NPP FENNOVOIMA (HANHIKIVI 1)

Expert Statement to the EIA Program

Oda Becker

By Order of the
Federal Ministry for Agriculture, Forestry,
Environment and Water Management,
Project Management Department V/6
“Nuclear Coordination”
GZ MBLFUW-UW.1.1.2/0006-V/6/2013
and the Government of Lower Austria

Figure 1: VVER Technology Evolution

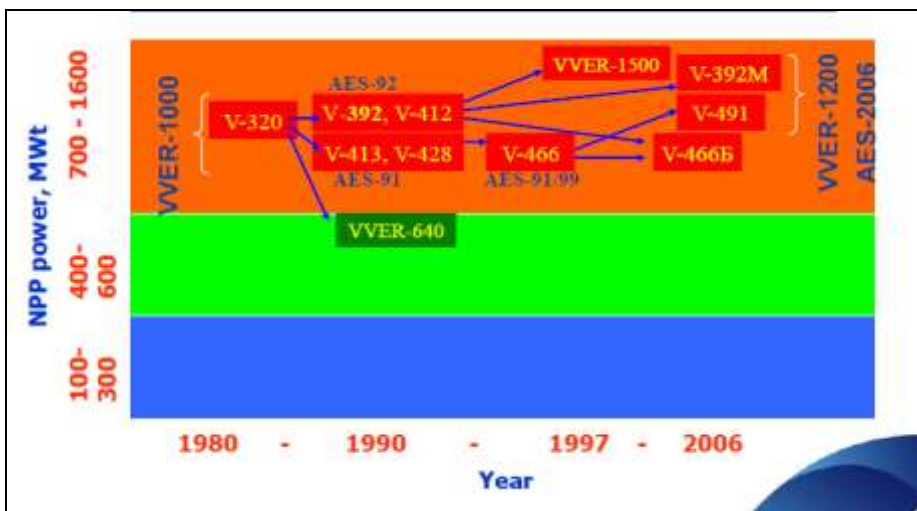
Two variants of the AES-2006 have been developed (see figure 1): Passive safety systems prevail in the type VVER-1200/V-392M, whereas the type VVER-1200/V-491 focuses more on active systems (UMWELTBUNDESAMT 2009b). The EIA program does not mention which variant is chosen for Hanhikivi 1. **It is recommended to explain which variant of the AES-2006 is chosen as well as the reason for this choice.**
